ALERT SERVICE BULLETIN

NO. 412-00-105

**SUBJECT: MAIN HYDRAULIC SERVO ACTUATOR ROD
END LOCK WASHER, INSPECTION AND
REPLACEMENT OF**

FLIGHT CONTROLS – HYDRAULIC SERVO ACTUATOR INSPECTION FOR DAMAGED LOCKING WASHER

Figure 1

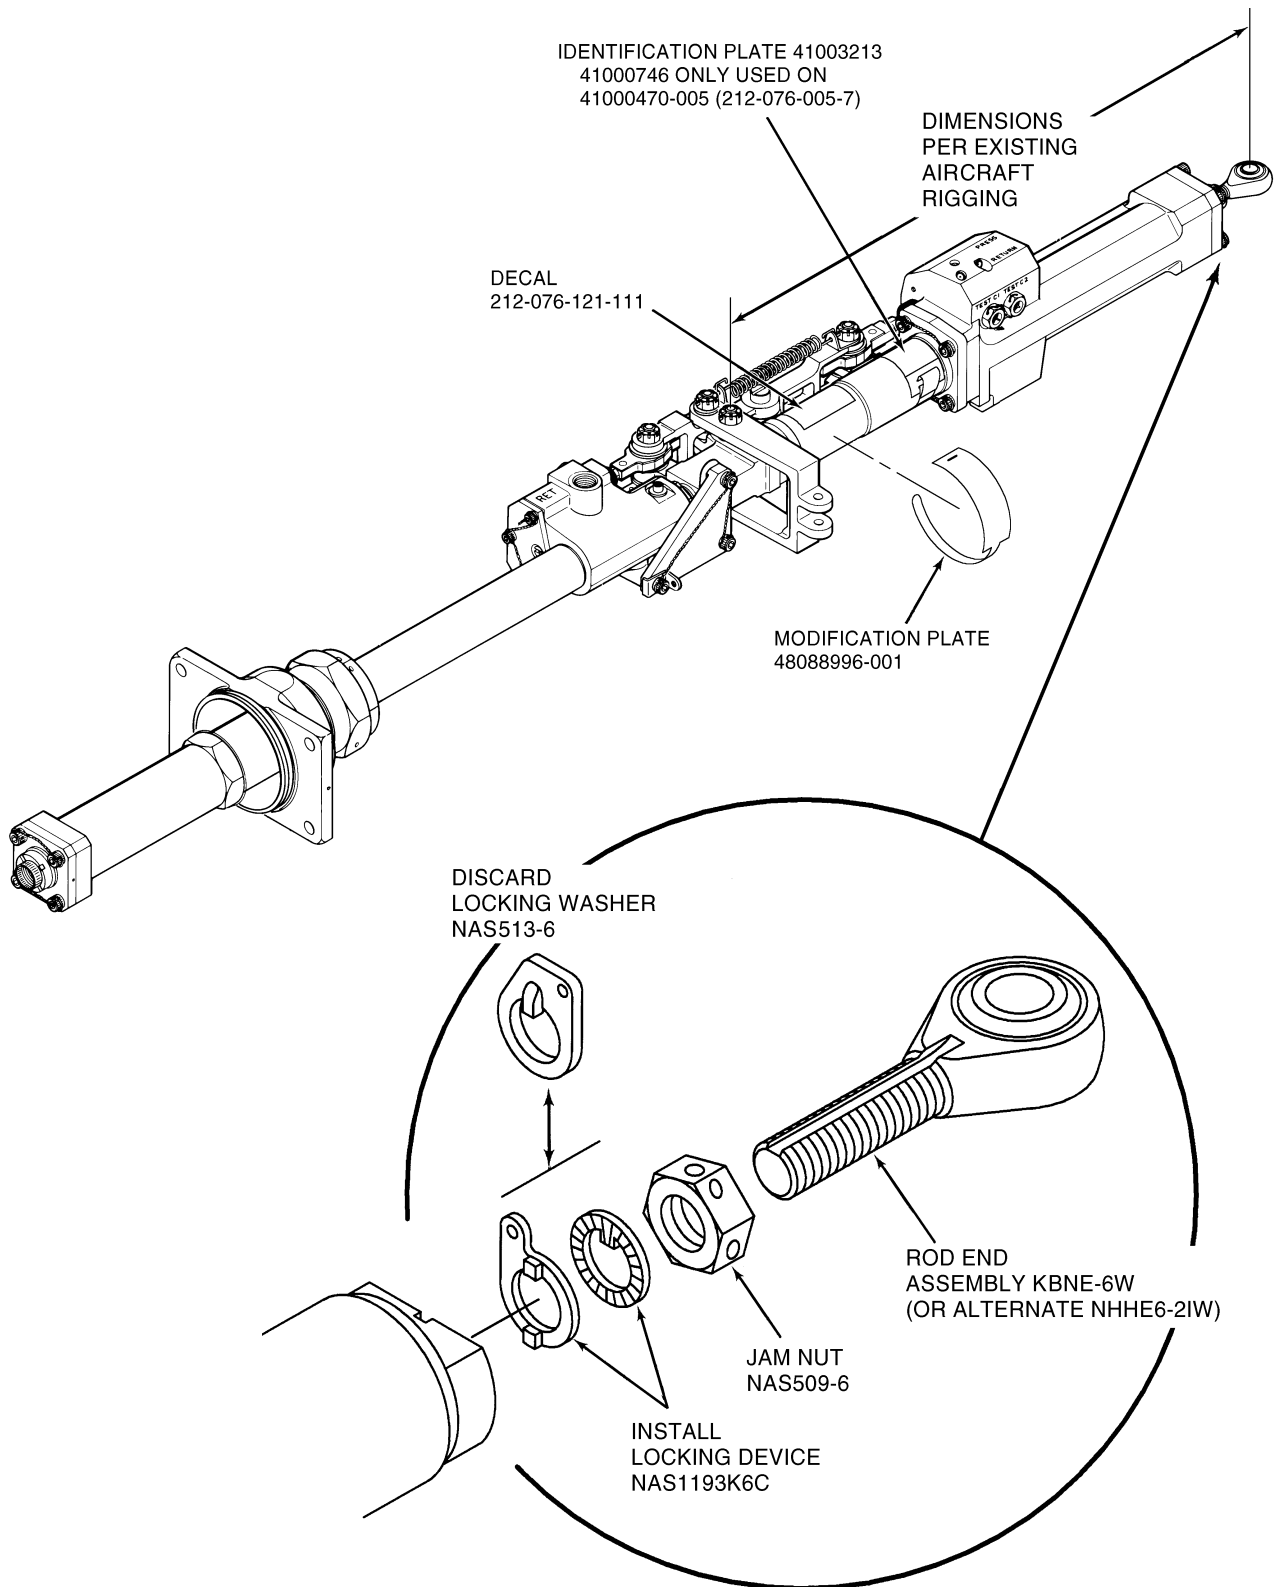
A customer recently discovered a damaged locking washer that had allowed the piston to back itself out of the locking jam nut (Figure 1). This condition prevented the aircraft from taking off and presented a Safety of Flight condition. Bell Helicopter's subsequent investigation determined that all existing locking washers NAS513-6 used on applicable actuators shall be replaced with new locking devices NAS1193K6C.

- (1) Without removing actuator from aircraft, gain access to locking washer (Figure 1).
- (2) Visually inspect locking washer to ensure it is not broken. Tab shall be in groove of rod end assembly. Immediately replace any locking washer whose tab is twisted or hanging askew.

- (7) Carefully install new 2-piece locking device NAS1193K6C onto rod end assembly. Refer to Figure 1 and the following substeps:
 - (a) Install round ring onto threaded rod so that tab fits into groove on rod end and serrated side faces away from jam nut.

- (b) Install oblong ring onto threaded rod so that serrated side will engage serrated side of round ring.
- (8) Install rod end assembly into threads of piston assembly. With piston assembly bottomed in cylinder assembly, establish the same dimension that was recorded in step 3.

- (9) Slide oblong ring (part of new locking device NAS1193K6C) so that two locking tabs fit into slots on end of piston assembly. Slide round ring (also part of new locking device NAS1193K6C) to engage oblong ring.
